SUBJECT: ISSUANCE OF AMENDMENTS FOR DIABLO CANYON NUCLEAR POWER
PLANT, UNIT NO. 1 (TAC NO. MA3573) AND UNIT NO. 2 (TAC NO. MA3574)

These amendments revise the combined Technical Specifications (TS) for the Diablo Canyon Power Plant (DCPP) Unit Nos. 1 and 2 to revise TS 3/4.4.9.1, "Reactor Coolant System - Pressure/Temperature Limits," Figure 3.4-2,"Reactor Coolant System Heatup Limitations - Applicable Up to 12 EFPY," and Figure 3.4-3, "Reactor Coolant System Cooldown Limitations - Applicable Up to 12 EFPY," to extend the applicability up to 16 effective full power years (EFPY). The affected TS Bases would also be appropriately revised.

SAFETY EVALUATION BY THE OFFICE OF NUCLEAR REACTOR REGULATION
RELATED TO AMENDMENT NO. 133 TO FACILITY OPERATING LICENSE NO. DPR-80
AND AMENDMENT NO. 131 TO FACILITY OPERATING LICENSE NO. DPR-82
PACIFIC GAS AND ELECTRIC COMPANY
DIABLO CANYON NUCLEAR POWER PLANT, UNITS 1 AND 2
DOCKET NOS. 50-275 AND 50-323

FIGURE 3.4-2
 REACTOR COOLANT SYSTEM HEATUP LIMITATIONS - APPLICABLE UP TO 16 EFPY

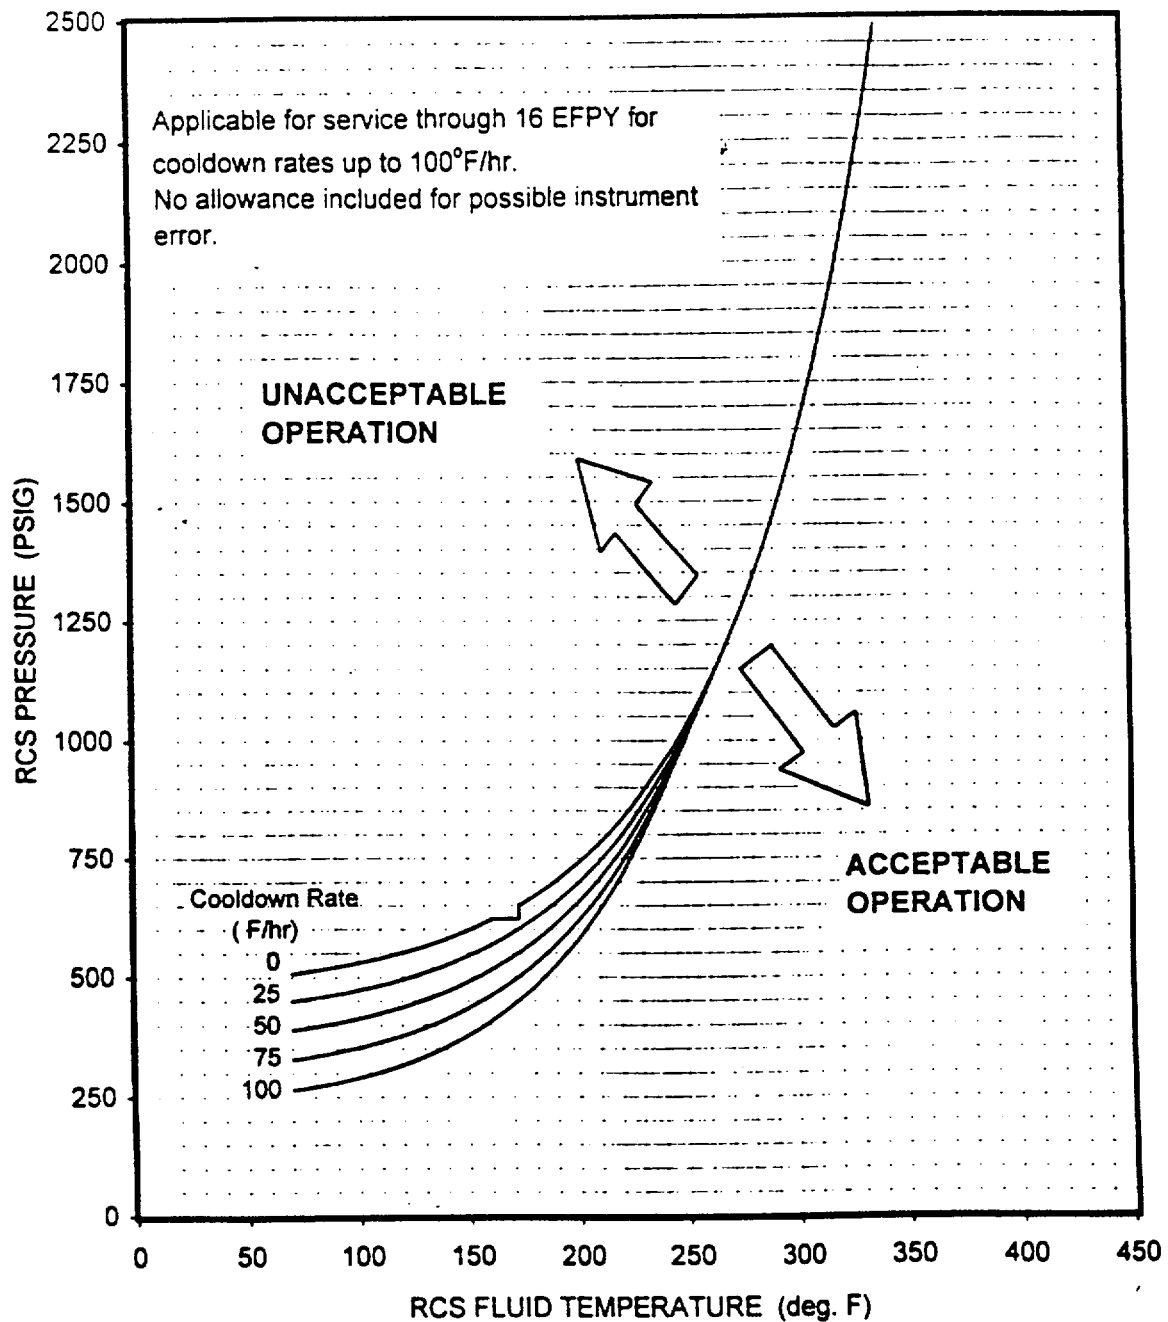
1. The reactor coolant temperature and pressure and system heatup and cooldown rates (with the exception of the pressurizer) shall be limited in accordance with Figures 3.4-2 and 3.4-3 for the service period specified thereon:

6. The criticality limit on Figure 3.4-2 is based on the minimum allowable temperature of 314°F for an inservice hydrostatic test of 110% of operating pressure.

PG&E's proposed P/T limit curves for normal operating and pressure testing conditions, effective to 16 EFY, are slightly more conservative than the P/T limit curves generated by the staff in accordance with the methods of Appendix G to the Code. The curves are in compliance with Appendix G of 10 CFR Part 50 and provide sufficient assurance that the DCPD reactors will be operated in a manner that will protect DCPD RPVs against brittle fracture. The staff confirmed that PG&E's P/T limit curves included the appropriate MTRs that were at least as conservative as those required by Appendix G of 10 CFR Part 50. Given these considerations, the staff therefore concludes that the proposed P/T limit curves, effective to 16 EFY, are in compliance with Appendix G of 10 CFR Part 50 and acceptable for incorporation into the DCPD TS.

² DCPD TS Figure 3.4-2 includes the proposed leak rate test curve, the heatup curve for the DCPD reactors when the cores are not critical, and heatup curve for the reactors when cores are critical. The heatup curves are based on heatup rates up to 60°F/Hr. DCPD TS Figure 3.4-3 includes the cooldown curves for DCPD reactors at cooling rates of 0°F/Hr, 25°F/Hr, 50°F/Hr, 75°F/Hr, and 100°F/Hr.

1/4T: Unit 1 Lower Shell Longitudinal Weld 3-442 C. RT_{ndt} @ 1/4T = 183.7°F.
 3/4T: Unit 2 Intermediate Shell Plate B5454-2. RT_{ndt} @ 3/4T = 151.4°F.
